**STATE OF NEW MEXICO  
ENERGY, MINERALS AND NATURAL RESOURCES DEPARTMENT  
OIL CONSERVATION DIVISION**

**APPLICATIONS OF CIMAREX ENERGY CO. FOR COMPULSORY POOLING, LEA  
COUNTY, NEW MEXICO**

**APPLICATIONS OF DEVON ENERGY PRODUCTION COMPANY, L.P. FOR  
COMPULSORY POOLING, LEA COUNTY, NEW MEXICO**

**NOTICE OF CIMAREX'S POST-HEARING EXHIBIT SUBMITTAL**

# **Revised Tract Map/Ownership For Cimarex Coriander Units-Post Conoco Trade\***

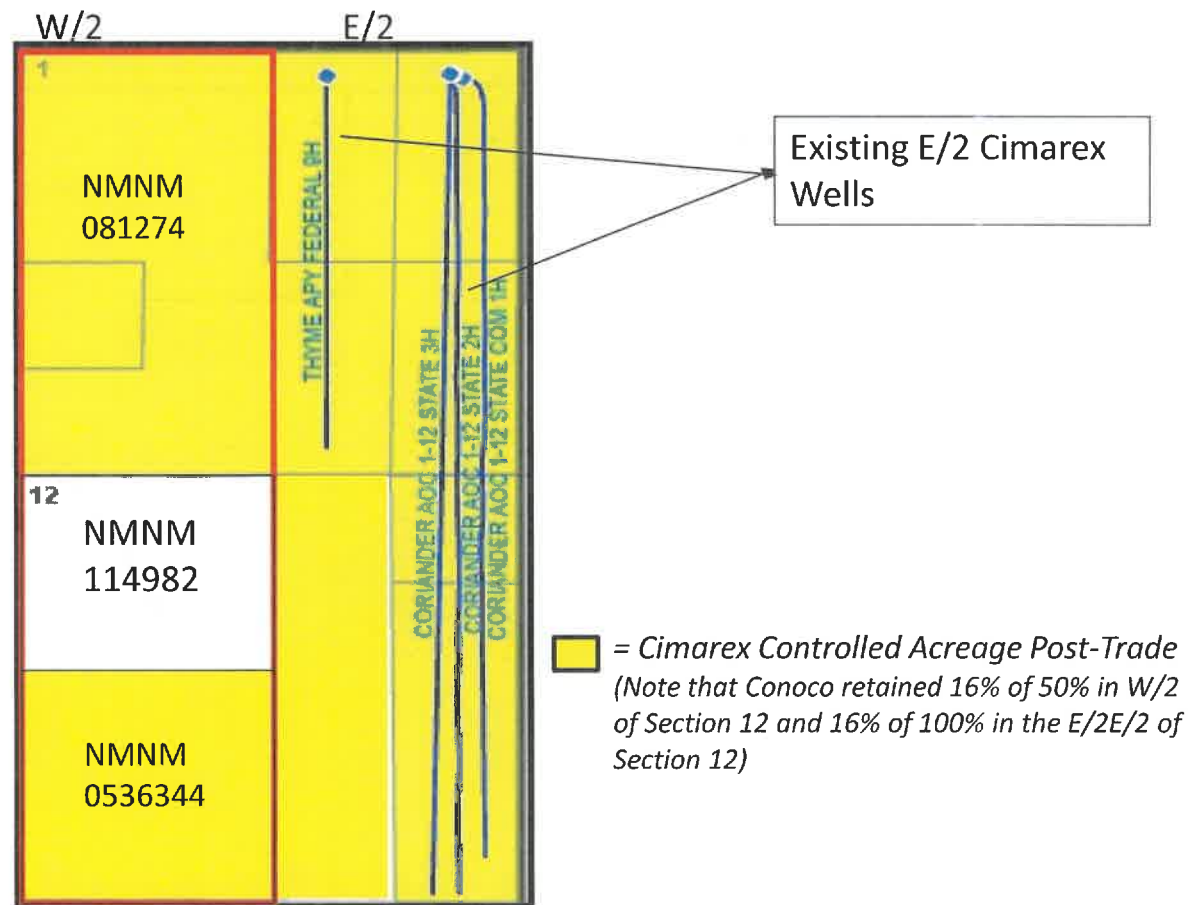
\*Revised B-9: Revised to update ownership in SW/4 of Section 12 and to reflect Cimarex controlled acreage post-trade. Revisions in italics.
